COMPETITIVE COMMENTS ON
2023 WAKE COUNTY ACUTE CARE BED NEED DETERMINATION
SUBMITTED BY DUKE UNIVERSITY HEALTH SYSTEM, INC.

SEPTEMBER 27, 2023

**COMMENTS SPECIFIC TO UNC HEALTH REX HOSPITAL
PROJECT ID NO. J-012417-23**

Overall 4 West Plan

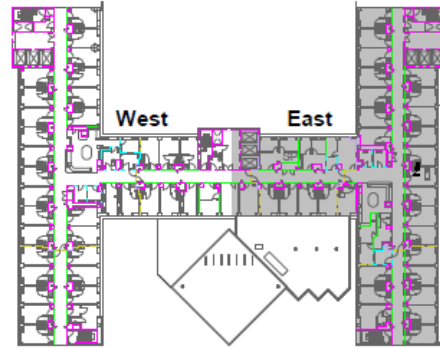
UNC Health REX proposes to renovate space to accommodate the incremental beds. It specifically identifies construction requirements and costs necessary to upgrade individual patient rooms to meet The Facilities Guidelines Institute requirements included in the 2023 edition, stating “renovation will also include all necessary electrical, HVAC, and plumbing work to meet current FGI Hospital Guidelines.” The application identifies existing rooms on 4 West and 6 East to meet those requirements.

However, UNC Health Rex does not identify any renovation to the units themselves. FGI characterizes projects modifying “an entire area,” which would include a patient unit with multiple rooms, as “major renovation projects” that must meet the requirements for new construction to the extent possible. See FGI Section 1.1-3.1.12 (3). To the extent that the proposed renovation of 3 East and 4 West appears to encompass entire units, the entire spaces, not just the patient rooms, would be required to meet FGI 2023 2.1 Common Elements for Hospitals standards including but not limited to:

UNC Health Rex did not include the costs of renovating all of these support spaces to meet these requirements. These renovations would also affect the construction timetable. These renovations could also affect the feasibility of accommodating the same number of patient rooms on the unit.
